Re: McGuire Nuclear Station, Unit 2
Docket No. 50-370
Request for Relief from ASME Code Section XI Requirement Determined to be
Impractical

REQUEST FOR RELIEF FROM ASME CODE SECTION XI
REQUIREMENT DETERMINED TO BE IMPRACTICAL

Figure 10.3.2-1
(1 of 3)
Revision 39

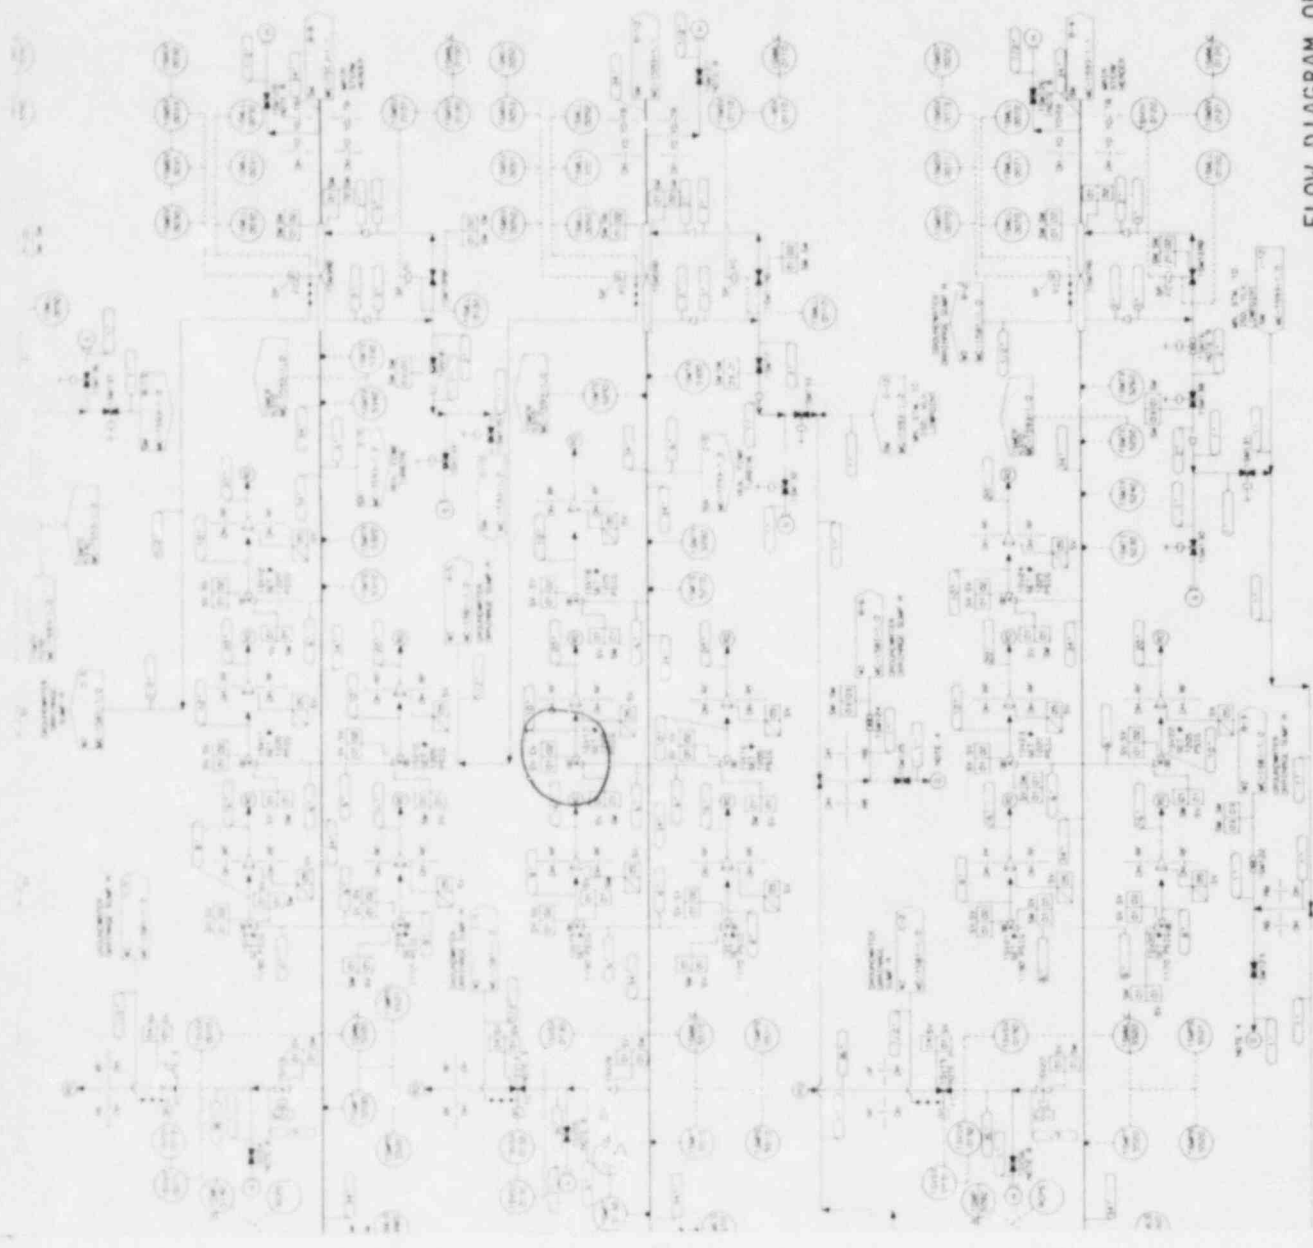
Note that this section of the main steam system falls into the same area as that for which exemption from hydrostatic testing was requested for the feedwater nozzle modification of the Units 1 and 2 steam generators (reference my letters dated September 14 and October 19, 1982). Also attached is McGuire FSAR Fig. 10.3.2-1(1 of 3) with the corresponding Unit 1 valve highlighted, showing the valve's location in the main steam system. Although the Figure is of Unit 1, the Unit 1 and 2 systems are identical.

Relief valve 2SV-17, which is a main steam vent to atmosphere; it has a 6" inlet and a 10" outlet. The 6" weld which attaches the valve to the (SM) main steam system is the weld for which relief from hydro is requested.

Weld: The valve is welded to the main steam line. The weld number is SM2FW12-22, and the joint thickness is 1.5 inches.

A 100% radiographic examination of the pressure boundary weld has been made and accepted. In addition, U.T. examination will be performed in accordance with ASME Section V, article 5, and also a weld surface examination by PT. Although the geometry in the area to be examined presents difficulties for a U.T. examination, it will be performed on a "best effort" basis. Also, an inservice leak test at system pressure and temperature will be performed at the earliest possible time, along with a hydro test to be performed at the 10-year inspection interval per section XI of the ASME code.
